# UNITED STATES PATENT AND TRADEMARK OFFICE

APPLICATION NO.	FILING DATE	FIRST NAMED INVENTOR	ATTORNEY DOCKET NO.	CONFIRMATION NO.
10/733,160	12/10/2003	Robert L. Doubler	6683.99US01	5934
21917	7590	11/18/2005		
MCHALE & SLAVIN, P.A. 2855 PGA BLVD PALM BEACH GARDENS, FL 33410				
			EXAMINER FERGUSON, MICHAEL P	
			ART UNIT	PAPER NUMBER
			3679

**Office Action Summary**

## **DETAILED ACTION**

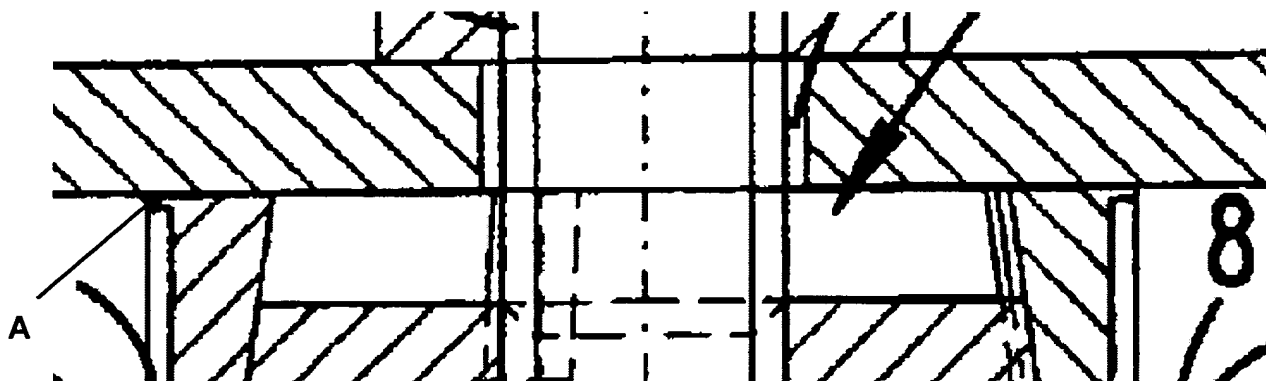
a body member **7** having an outer surface positioned about a central axis, the body member having a first end including a cavity, the cavity having an engaging surface, the engaging surface tapering inwardly from about the first end and extending toward a second end, the second end defining a clamping surface **A** (clamping against object **3**; Figure 6 reprinted below with annotations) adapted to engage the object;

a body member **7** defining a longitudinal axis and comprising a clamping end **A** (clamping against object **3**; Figure 6) adapted to engage an object **3** to be fastened, and an expandable portion **16** radially expandable relative to the longitudinal axis, the expandable portion having an inner surface defining a cavity in the body member and an outer surface;

As to claim 23, Krüger et al. disclose a fastener wherein the machinery component **2,4** comprises a portion (bolt **15**) adapted to support the object **3** to be fastened against the clamping end **A** (Figure 6).

As to claim 24, Krüger et al. disclose a fastener wherein both of the outer surface of the expander member **14** and the inner surface of the expandable portion **16** of the body member **7** has a portion at an angle from the longitudinal axis and adapted to remain in contact with the other one of the outer surface of the expander member and the inner surface of the expandable portion of the body member during the longitudinal advancement of the expander member (Figure 6).

As to claim 25, Krüger et al. disclose a fastener wherein the expandable portion **16** of the body member **7** has a portion at an angle from the longitudinal axis and adapted to remain in contact with the gripping surface **4** during the radial expansion of the expandable portion of the body member (Figure 6).

Examiner disagrees. As to claim 1, Krüger et al. disclose a fastener system wherein the body member **7** outer surface and the gripping surface **4** are configured and positionable relative to each other to from a compressive contact with each other to linearly shift relative to each other under the compressive contact to cause an increased compression between the clamping surface **A** and the object **3** when the body member is circumferentially expanded from an unloaded state (Figures 2 and 6).
